Process Sheet

Customer : CU-DAR001 Dart Helicopters Services Drawing Name : SKID TUBE ASSEMBLY
 Job Number : 32972
 Estimate Number : 12520
 P.O. Number : *N/A* Part Number : D205634045
 This Issue : 6/19/2007 S.O. No. : *N/A* Drawing Number : D2580 REV C/DE09183B
 Prsht Rev. : NC Project Number : *N/A*
 First Issue : *N/A* Type : LANDING GEAR Drawing Revision : C/B
 Previous Run : 32971 Material : *N/A*
 Due Date : 7/11/2007 Qty: 1 Um: Each
 Written By :
 Checked & Approved By : *[Signature]*
 Comment : Est Rev:C Revised Steps 06-09-06 JLM

DESIGN RF	DRAWN BY RF	DART AEROSPACE LTD HAWKESBURY, ONTARIO, CANADA	
CHECKED #	APPROVED #	DRAWING NO. DEO 9183	REV. B SHEET 1 OF 1
DATE 00.05.15		TITLE ADD SKIDTUBE P/N D2580-045	SCALE NTS
A	00.03.29	NEW ISSUE	
B	00.05.15	39.580 WAS 39.620

AMEND DRAWING D2580 REV. C TO ADD D2580-045 ASSEMBLY

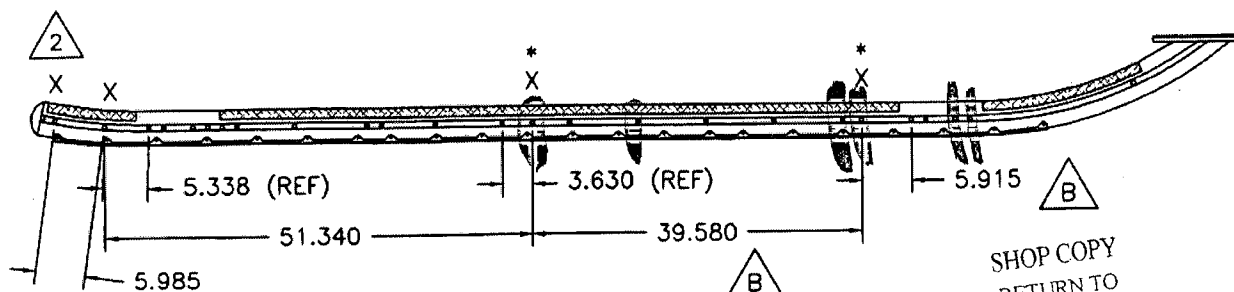
D2580-045 IS IDENTICAL TO D2580-041, EXCEPT FOR THE FOLLOWING CHANGES:

- 1) INSTALL CROSS BOLT SPACERS AT LOCATIONS MARKED 'X' ACCORDING TO THE FOLLOWING PROCEDURE.
 - a) DRILL $\varnothing 0.508$ HOLES AT LOCATIONS SHOWN BELOW MARKED 'X'.
CHAMFER HOLES $0.030 \times 45^\circ$. NOTE THAT HOLES WILL ALSO HAVE TO BE TRANSFERRED TO THE D2596 WEB AT THE * LOCATIONS. IT IS ACCEPTABLE TO PRE-DRILL THE D2596 WEB IN THESE LOCATIONS BEFORE INSTALLING THE WEB IN THE SKIDTUBE. OPEN HOLES TO $\varnothing 0.63$ AND TOUCH UP WITH ALODINE PER QSI 005 4.1.

- b) INSERT D2579 CROSS BOLT SPACERS INTO THE HOLES.
 - c) WELD INTO PLACE PER DART QSI 004 AND GRIND FLUSH.
 - d) REMOVE SPILL OVER LEAVING HOLE DIMENSION $\varnothing 0.380$ - $\varnothing 0.390$.

- 2) IT IS ACCEPTABLE TO GRIND A RELIEF IN THE D2855 AFT CAP TO PREVENT INTERFERENCE WITH THE SPACER AT THIS LOCATION.
- 3) POWDER COAT ENTIRE ASSEMBLY GREEN (REF. 4.3.5.8) PER DART QSI 005 4.3 INSTEAD OF WHITE (REF. 4.3.5.1).
